Confirmation of GRSP on draft interpretation “one belt route” UN R129

Submitted by the expert from the Netherlands *

two webbing paths, one belt route (as they are mirror image of each other)

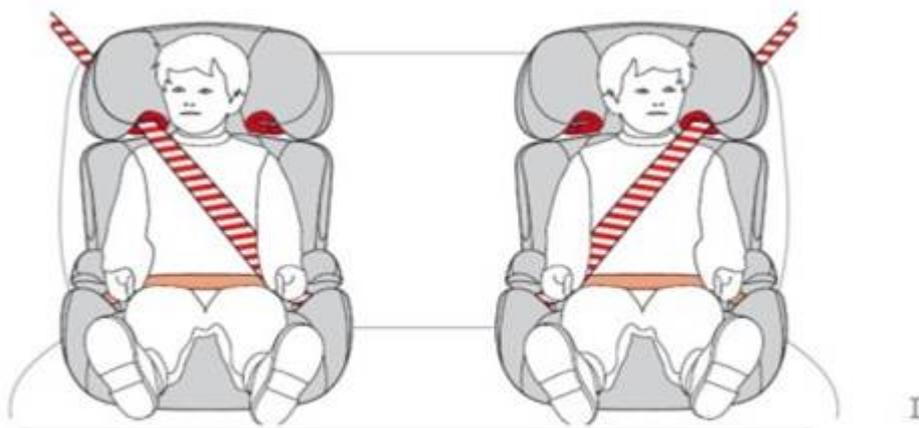
When moving an ECRS from e.g. the left outboard seating position to the right outboard seating position the actual route of the adult vehicle belt can be different. If these actual routes differ only in symmetry, then these 2 actual routes are considered to be mirror images of the same belt route.

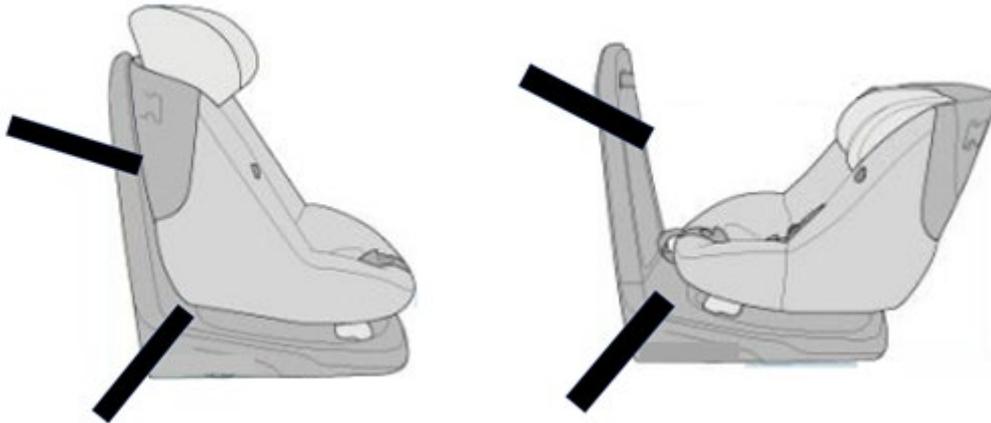
Because of this, NL decided that the shown concept does not conform to the definition of 'one belt route', since the belt routes in forward facing direction and rearward facing direction differ from each other and may result in misuse by the end user.

There are several alternatives which may be used to prevent misuse, e.g. by using a separate base in combination with a turn able seat shell. De base is installed using the 3-point belt and the turn able seat shell can be used in both forward and rearward direction without having to re install the 3-point belt. (see example below)
